# Olympic Valley Groundwater Management Plan Appendices

*Prepared for:  
Squaw Valley Public Service District*

**May 2007**  
(Revised June 1, 2007)

# SQUAW CREEK FISH SURVEY

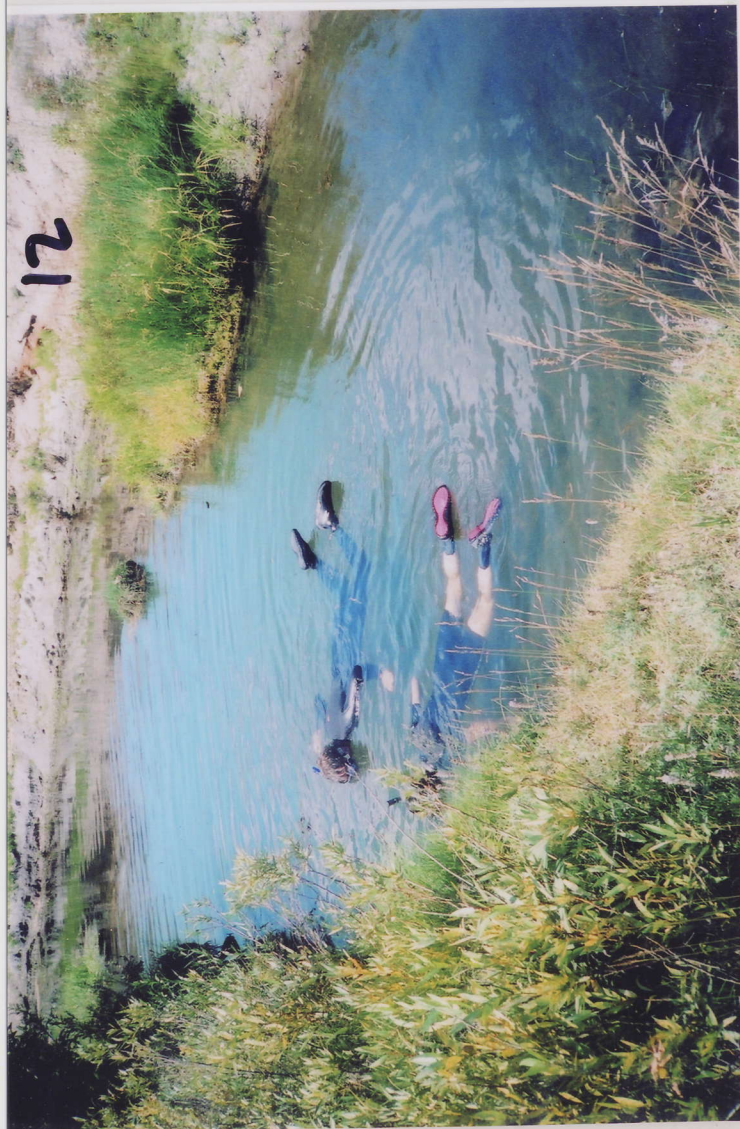
ATTACHED ARE SOME OF MY PHOTOS WHICH SHOW IN PART MY OBSERVATIONS OF SQUAW CREEK
